**RC245009 - PROPOSED CHURCH
999 GOULDS ROAD, ROLLESTON**

1. Further to our correspondence, this letter sets out our review of transport information provided for the proposed Church at 999 Goulds Road, Rolleston. This information includes:

Figure 2: Rufus St Boundaries

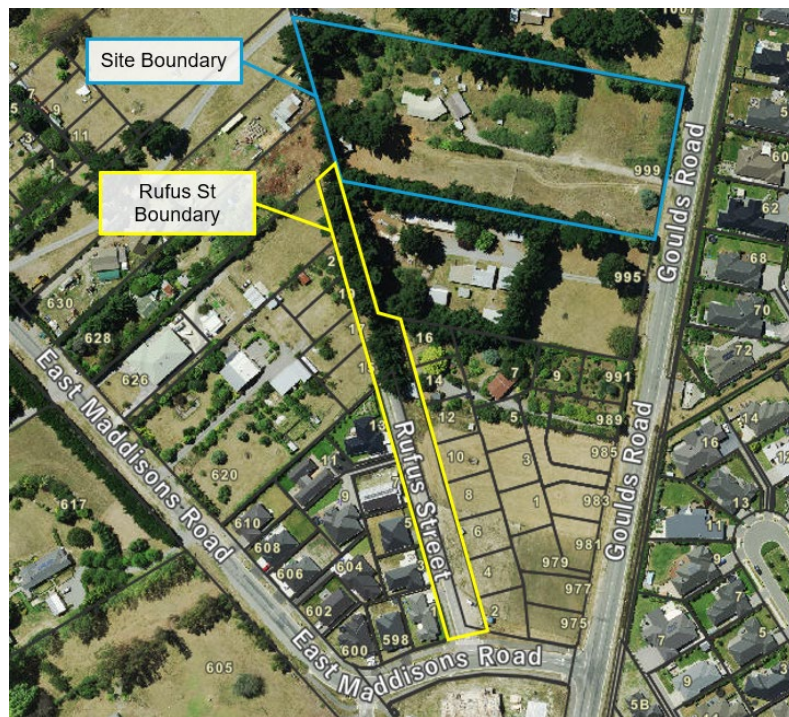
24. The Outline Development Plan for DEV-RO3 illustrates an indicative road that will form an extension to Rufus Street running along the western boundary of the Site. **Figure 2** (below) illustrates the existing formation of Rufus Street and it can be seen that the existing development pattern to the south has allowed for half of the Rufus Street continuation on the sites that front East Maddisons Road, with the assumption that development of the sites fronting Goulds Road will provide the other half.

25. The proposed development does not include provision for the Rufus Street extension, although the proposal is not subdivision. We also note that the development proposal does not include development within the area that would be expected to be road, so the development does not preclude the ability to construct that road in the future (should subdivision occur).

26. The concern we have is that not providing the road corridor has the potential to frustrate development of adjacent land. There is also potential that the proposed Church reduces the likelihood for further development of the Application site, such that the road corridor is not provided for some time.

27. We are not aware of there being a mechanism by which Council could insist on the land for the road corridor being provided through the Resource Consent process. That said, the preference is that the area of future road corridor be surveyed off by Council and vested, although we understand it could be made available to the Applicant until such time as it is required for the formation of Rufus Street (i.e. when adjoining development progresses).

31. We accept that there does not appear to be a mechanism for Council to require the land for the Rufus Street extension, although we would encourage the Applicant to liaise with

Council to seek a solution to this matter to ensure ongoing development that is consistent with the ODP for this land is not frustrated.

Figure X: Additional Car Parking Area

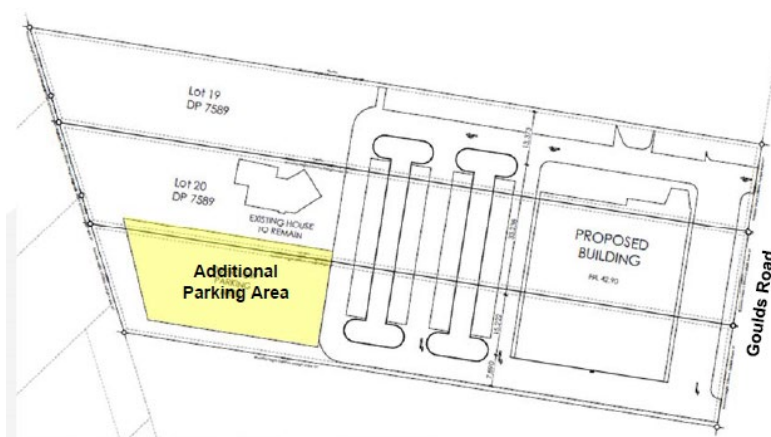
- a. The area identified for additional car parking in Figure X shall be formed such that it can accommodate intermittent car parking associated with large events, such as conferences. This shall include providing a level trafficable surface (albeit potentially grassed) with a means of access (such as kerb drop-down). This area shall be made available at times when it is expected that the capacity of the permanent car parking will be exceeded.
